4000404 CONCRETE STRUCTURES  
COMMENTS FROM INTERNAL/INDUSTRY REVIEW

Comment: (5-8-14) (Internal Review)

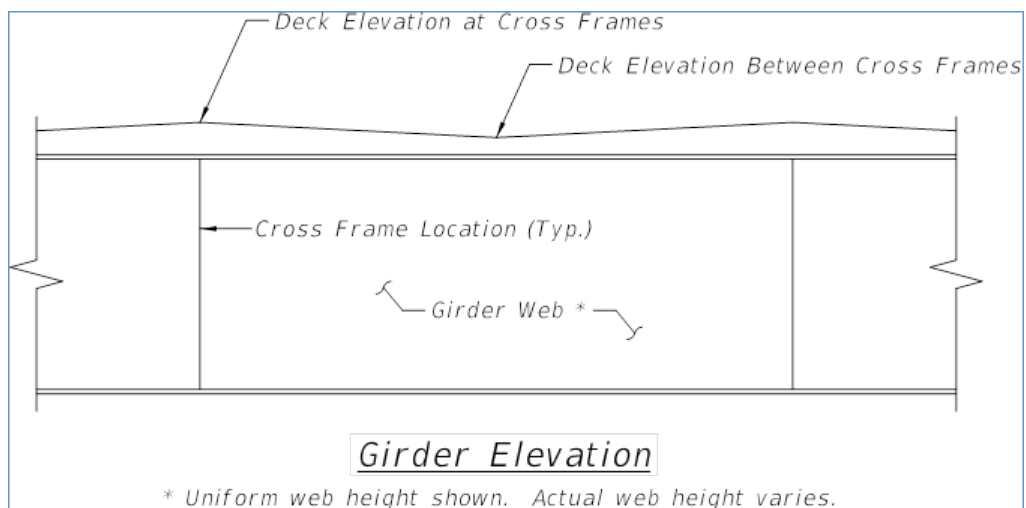
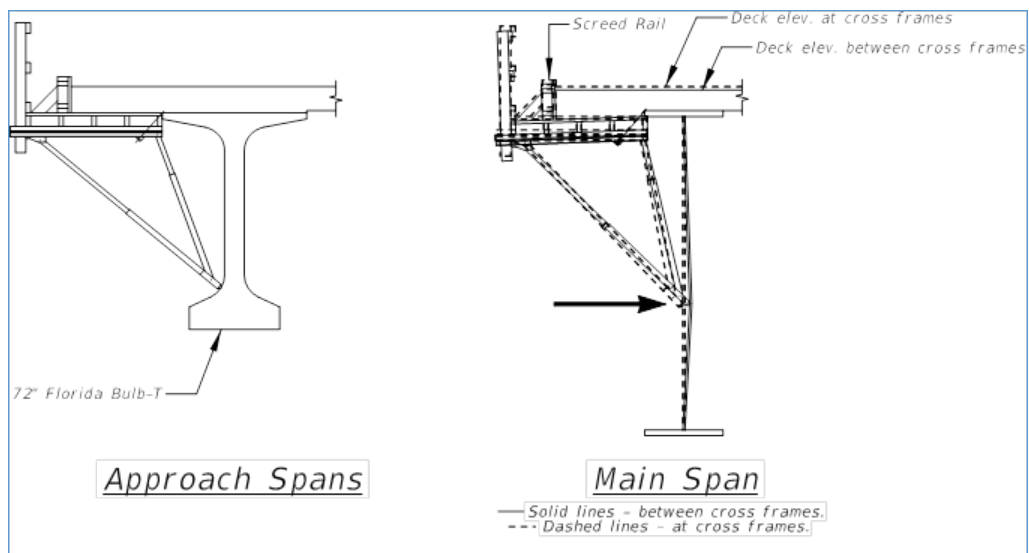
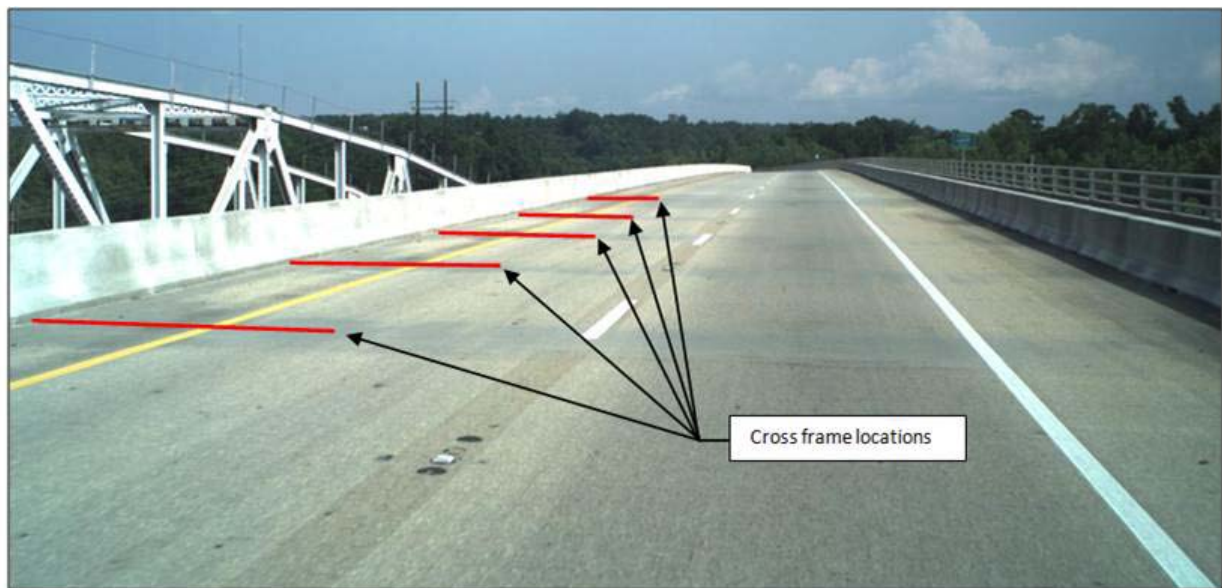
Most long span steel we see is in locations that fall under “public safety” and would require signed & sealed calculations anyway. I see this as a means & methods thing that hasn’t been a problem for years. Why add to the specifications now?

(Robert Robertson response): The issue of beam rotation and the need to control the location of the overhang deck form has been known for many years and improper brace locations have been witnessed many times over the years and is still being done today. This is not a new problem that we are resolving as it a discussion point in a Construction self study course and acknowledged by Steve Plotkin in an NCHRP survey in 2005. We offered the language in an effort to be preventative and minimize efforts by the contractor to meet deck acceptability standards. AASHTO discusses the issue in both the Construction and Design specifications. We initiated the spec revision as part of our effort to evaluate girder stability that also resulted in new requirements for temporary beam bracing. I do not know why this requirement was not already included in the specifications, or at least as a specification requirement for the Specialty Engineer to properly evaluate the specific issue. Generally the Specialty Engineer calculations we have seen are more about global stability and not inclusive of this issue.

The current specification language does not address the issue of screed rails supported by bridge deck overhang falsework on steel I-girders during deck placement. The deck overhang falsework, which bears against steel I-girder webs during deck placement, supports the overhang formwork, wet deck concrete, screed machine and any construction loads. The steel I-girder supporting this falsework can experience excessive web plate deformations, top and bottom flange lateral bending deformations, and out-of-plane rotations, especially between cross frame bracing points. The girder deformations and rotations translate to vertical deflections of the screed rails which can result in poor bridge deck profiles, loss of structural bridge deck concrete thickness, loss of concrete cover for bridge deck reinforcing steel, and ponding of water along the toe of concrete railings.

Keep in mind that this is language written to the designer and is mostly intended as a strength check, not a constructability check. For conventional design-bid-build projects the designer can't possibly know or accurately predict what bracket size and spacing the contractor will use. Even in a design-build scenario the designer will not likely have the necessary information from the contractor to properly consider the need for temporary bracing during the design. The Contractor's Engineer should be responsible to investigate the need for temporary bracing because the deck overhang falsework size, spacing, and construction loads are only known at the time of construction. See the following from Article 11.8.6.1.2 of the AASHTO LRFD Bridge Construction Specifications:

*"Wherever practical, overhang brackets should bear ear the bottom flange and be attached to the top flange. If overhang brackets bear against the web, the Contractor's Engineer shall ensure that precautions have been taken to prevent permanent deformation of the web and excessive deflection of the wet slab and forms. The lateral force on the top flange due to overhang brackets shall be investigated to ensure that the flange is adequate as specified in Article 6.10.3.4, "Deck Placement," of the AASHTO LRFD Bridge Design Specifications."*

A sensitivity study performed by our office shows that if bridge deck overhang falsework bears more than 6" above the bottom flange and/or the concrete deck overhang is 4 feet or greater, the deflections of the screed rail between cross frames can well exceed 1/4", with some deflections well exceeding 1/2". These deflections may or may not be correctable with grinding of the deck. Section 400-15.2.5.5 (smoothness evaluation for long bridges) requires that a minimum of 1/4" of the deck be planed off, and allows up to 1/2" of deck planing to meet the smoothness criteria; however, it is not preferred or recommended to eat into the 1/4" of reserve thickness.

This is not a new problem and has been observed in Florida and around the country. This picture is from SR 20 over Apalachicola River. The cross frame locations are clearly visible after deck grinding. The contractor used the same overhang brackets on the steel plate girder main span structure that were used for the 72" Florida Bulb-T approach span beams. The overhang brackets were braced too high on the girder web resulting in web distortion and problems with the deck profile. The deck profile is rough and water ponds along the toe of the concrete railing. See Steve Plotkin's response to a state survey questionnaire for NCHRP Synthesis 345 - Steel Bridge Erection Practices, 2005: *"Bridge with 9-ft deep girders where overhang brackets did not extend to bottom flange of girders. Webs deflected badly and the deck ride was bad. Had to grind deck for ride and bore holes in deck because of ponding. Ride still bad."*
